VALUE ENGINEERING TRAINING STUDY REPORT

Linecrest Road over Conley Creek

Project No. BRZLB-0089-00(007)

November 12, 2009

Idea No. : A-1

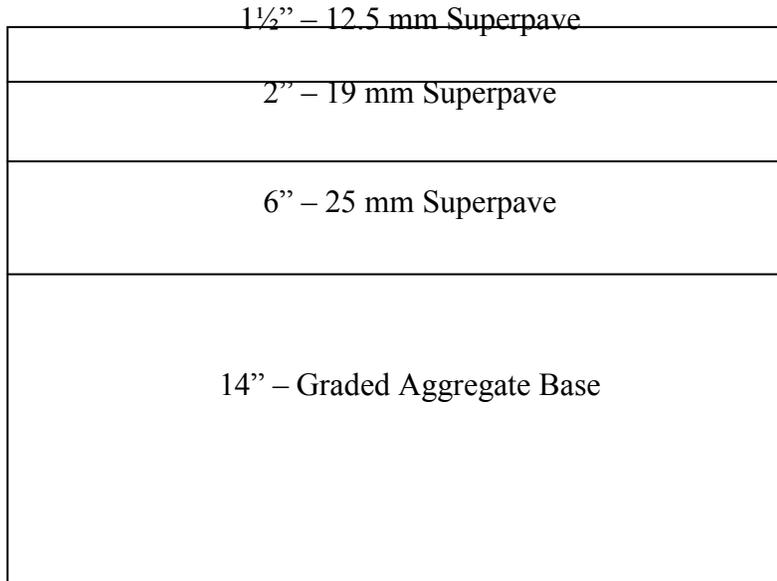
DEVELOPMENT AND RECOMMENDATION PHASE			
Project: Linecrest Road over Conley Creek			
Idea No.: A-1	Sheet No.: of	CREATIVE IDEA: Reduce amount of asphalt on Linecrest Road, by using a deeper layer of graded aggregate base (GAB).	
Comp By: ADY	Date: 10.19.2009	Checked By:	Date:
<p>Original Concept: Use: 1½” – 12.5 mm Superpave (165 lbs/sy) 3” – 19 mm Superpave (330 lbs/sy) 6” – 25 mm Superpave (660 lbs/sy) 12” – Graded Aggregate Base (GAB)</p> <p>Proposed Change: Use: 1½” – 12.5 mm Superpave (165 lbs/sy) 2” – 19 mm Superpave (220 lbs/sy) 6” – 25 mm Superpave (660 lbs/sy) 14” – Graded Aggregate Base (GAB)</p> <p>Justification: Graded aggregate base material has a significantly lower cost than any hot asphalt mix. In order to avoid compromising the pavement’s structural integrity, as the 19 mm superpave layer is reduced by 1”, the graded aggregate base is increased by 2”, slightly increasing the overall pavement depth by 1”. This design does not increase the number of lifts during construction. The amount of additional earthwork is considered negligible to affect grading complete.</p>

LIFE CYCLE COST SUMMARY	INITIAL Project Cost	FUTURE Project Cost	TOTAL Present Worth Cost
INITIAL COST: Original	\$571,000		
Proposed	\$527,000		
Savings	\$44,000		
FUTURE COST: Savings			\$0
TOTAL PRESENT WORTH SAVINGS			\$44,000.00

Idea No. : B-3 & 9
Client:: GDOT
Sheet 2 of 3

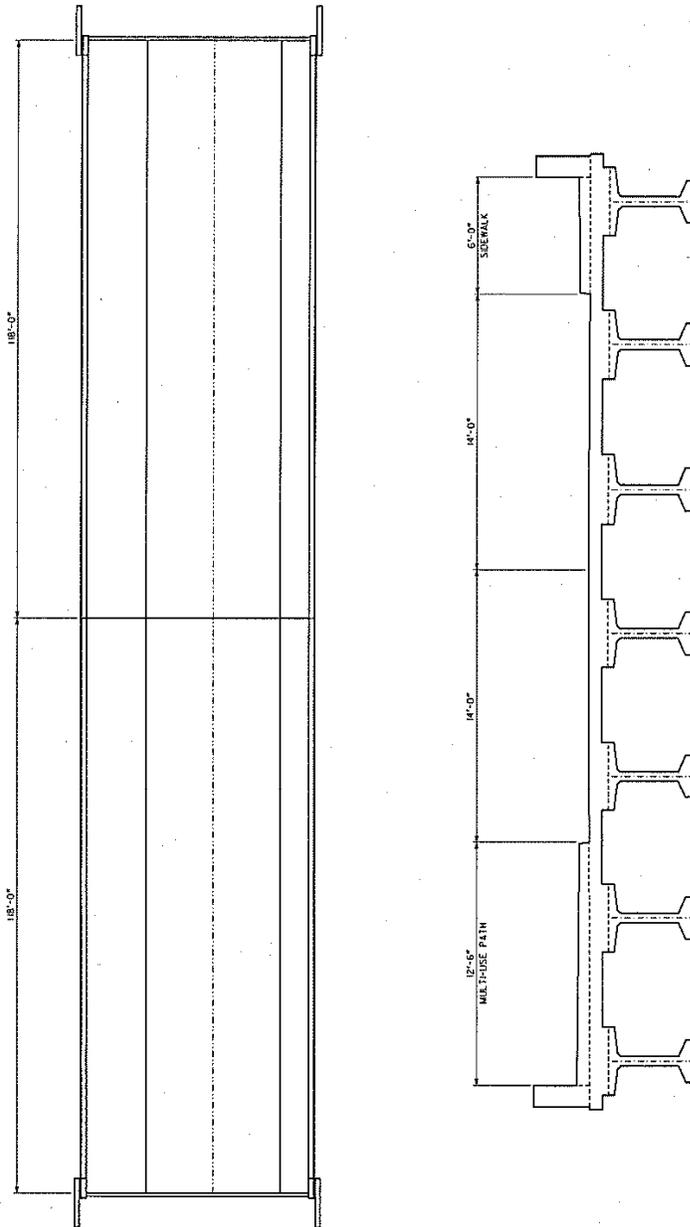
DEVELOPMENT AND RECOMMENDATION PHASE			
Project: CR 164 (Linecrest Road) over Conley Creek Tributary			
Idea No.: B-3 & 9	Sheet No.: 1 of 3	CREATIVE IDEA: Reduce the number of spans by using 54" bulb tee PSC beams thus eliminating 4 of 6 drilled caissons.	
Comp By: DLC		Date: 10/22/09	Checked By: Date:
Original Concept: Bridge consists of four 59'-0" spans using seven type II PSC beams on six 3'-6" drilled caissons.			
Proposed Change: Proposed bridge consists of two 118'-0" spans using seven 54" bulb tee PSC beams on two 7'-6" drilled caissons.			
Justification: Due to the height of the bridge over the design storm allows for the using of a deeper beam section. Presently the cost of 54" bulb tee PSC beams is less costly than the cost of type II PSC beam. The use of two 7'-6" drilled caissons (larger diameter/smaller number) in lieu more six 3'-6" drilled caissons (smaller diameter/larger number) would reduce the cost of the drilled caissons.

LIFE CYCLE COST SUMMARY	INITIAL Project Cost	FUTURE Project Cost	TOTAL Present Worth Cost
INITIAL COST: Original	308,625		
Proposed	260,113		
Savings	48,512		
FUTURE COST: Savings			0
TOTAL PRESENT WORTH SAVINGS			48,512

Idea No. : B-10
Client: : GDOT
Sheet 2 of 3

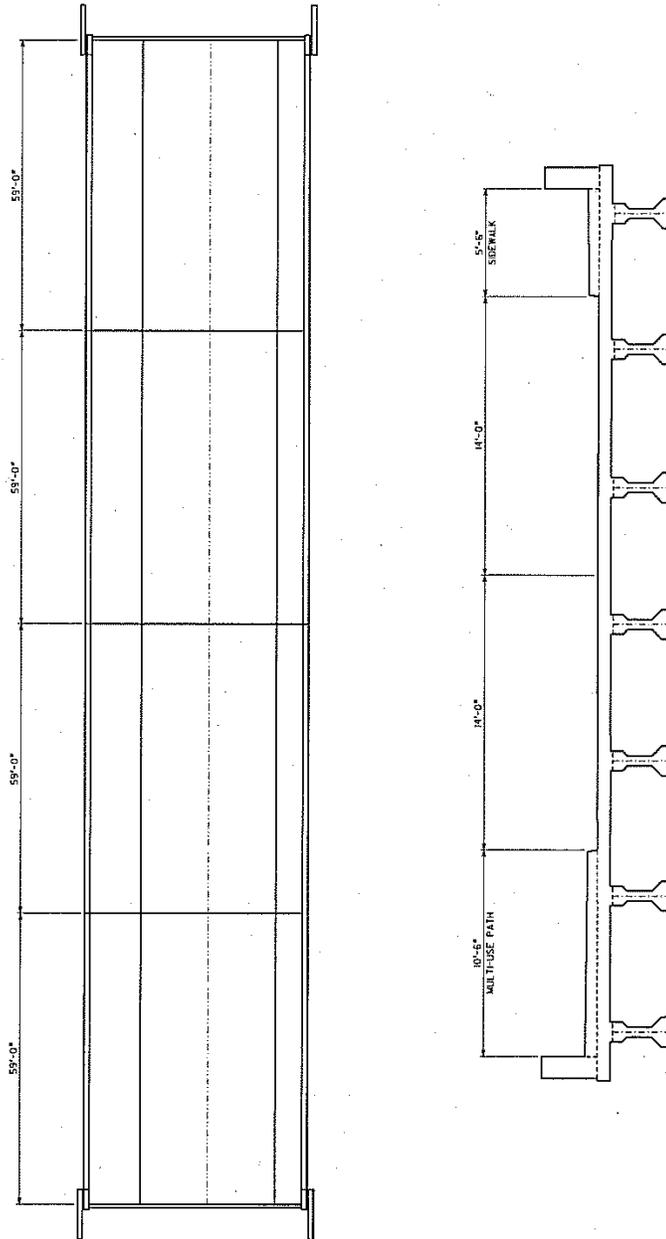
DEVELOPMENT AND RECOMMENDATION PHASE			
Project: CR 164 (Linecrest Road) over Conley Creek Tributary			
Idea No.: B-10	Sheet No.: 1 of 3	CREATIVE IDEA: Reduce the width of bridge by reducing the width of sidewalk and multi-use path.	
Comp By: DLC		Date: 10/22/09	Checked By: Date:
Original Concept: Bridge consists of one 6'-0" sidewalk and 12'-6" multi-use path for a total bridge with of 48'-10".			
Proposed Change: Proposed bridge one 5'-6" sidewalk and 10'-6" multi-use path for a total bridge width of 46'-4"			
Justification: Based on GDOT Bridge and Structures Design Policy Manual, the width of sidewalks on bridges shall be 5'-6" to accommodate a 5'-0" roadway sidewalk. Using the same philosophy, a 10'-0" multi-use path should be a 10'-6" width on the bridge.			
LIFE CYCLE COST SUMMARY	INITIAL Project Cost	FUTURE Project Cost	TOTAL Present Worth Cost
INITIAL COST: Original	1,217,040		
Proposed	1,154,736

Savings	62,304		
FUTURE COST: Savings			0
TOTAL PRESENT WORTH SAVINGS			62,604

Idea No. : B-11
Client: : GDOT
Sheet 2 of 4

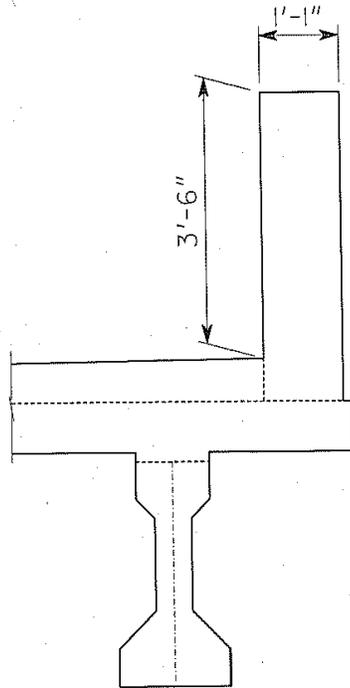
DEVELOPMENT AND RECOMMENDATION PHASE			
Project: CR 164 (Linecrest Road) over Conley Creek Tributary			
Idea No.: B-11	Sheet No.: 1 of 4	CREATIVE IDEA: Use 3'-6" parapet in lieu of special design concrete parapet (Texas Rail)	
Comp By: DLC		Date: 10/22/09	Checked By: Date:
<p>Original Concept:</p> <p>Special design concrete parapet.</p> <p>Proposed Change:</p> <p>3'-6" parapet.</p> <p>Justification:</p> <p>Provides same function at reduced cost. The cost of special design concrete parapet is over 9 percent of the total cost of the bridge.</p>			
LIFE CYCLE COST SUMMARY	INITIAL Project Cost	FUTURE Project Cost	TOTAL Present Worth Cost
INITIAL COST: Original	112,459		
Proposed	66,479		
Savings	45,980		
FUTURE COST: Savings			0
TOTAL PRESENT WORTH SAVINGS			45,980
